Plan Check Clarification

Date:	June 21, 2022	Project Name:	Park 70 – Bldgs 16-19
To:	Stephen Rodriguez Planning Supervisor City of Aurora	Project No.:	DEN21-0126-00
Subject:	Site Plan Comment Response	From:	Steve Smith
		Plan Check No.:	DA-1396-16

Right-of-way Frontage Exhibit

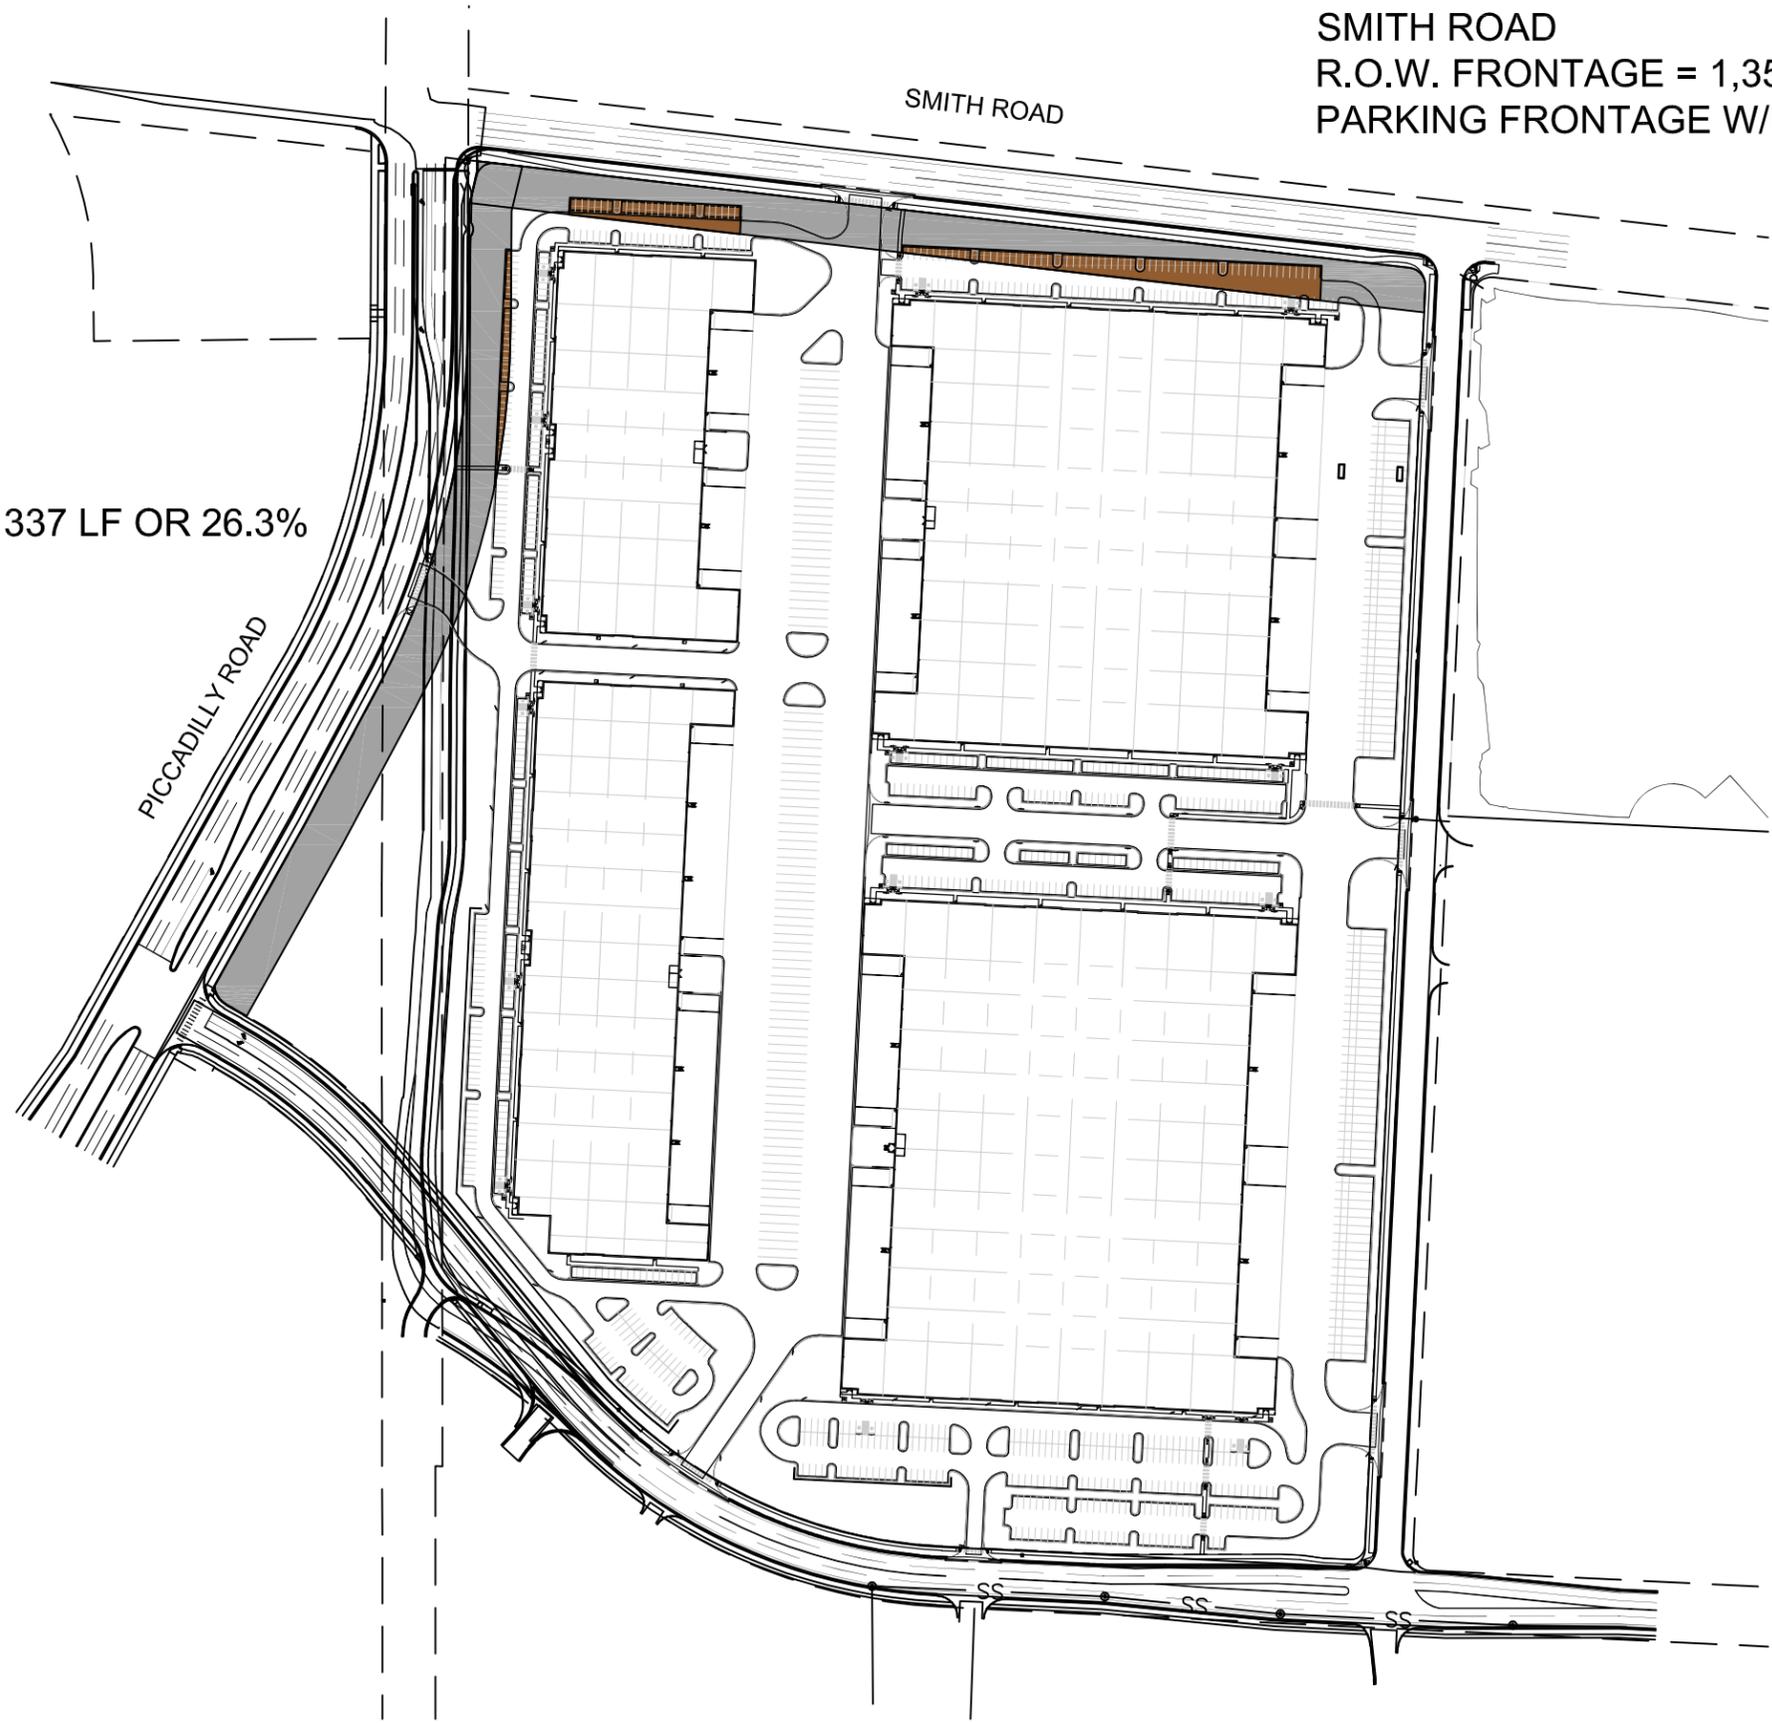
Response: Added.
- 1C. Update cover sheet data table to reflect maximum building height for I-1 Zone District is 100 feet.
Response: Updated.
- 1D. In Subarea C, no more than 60 percent of the lot frontage on a collector street to a depth of 60 feet shall be occupied by surface parking. Show measurement that you are meeting this requirement for parking along the street frontage. This requirement applies to Piccadilly Road and Smith road. Update the site plan to show that you are meeting this requirement.

Response: Please see the attached exhibit at the end of this comment response that shows compliance on Piccadilly and Smith Road.
- 1E. Per the Unified Development Ordinance, Section 146-4.8.4, in the I-1 District each primary structure shall be arranged so that the primary façade and each façade with a main pedestrian entry, orients onto and provides direct pedestrian access onto, one of the following.

SMITH ROAD
R.O.W. FRONTAGE = 1,357 LF
PARKING FRONTAGE W/IN 60' = 783 LF OR 57.7%

PICCADILLY ROAD
R.O.W. FRONTAGE = 1,282 LF
PARKING FRONTAGE W/IN 60' = 337 LF OR 26.3%
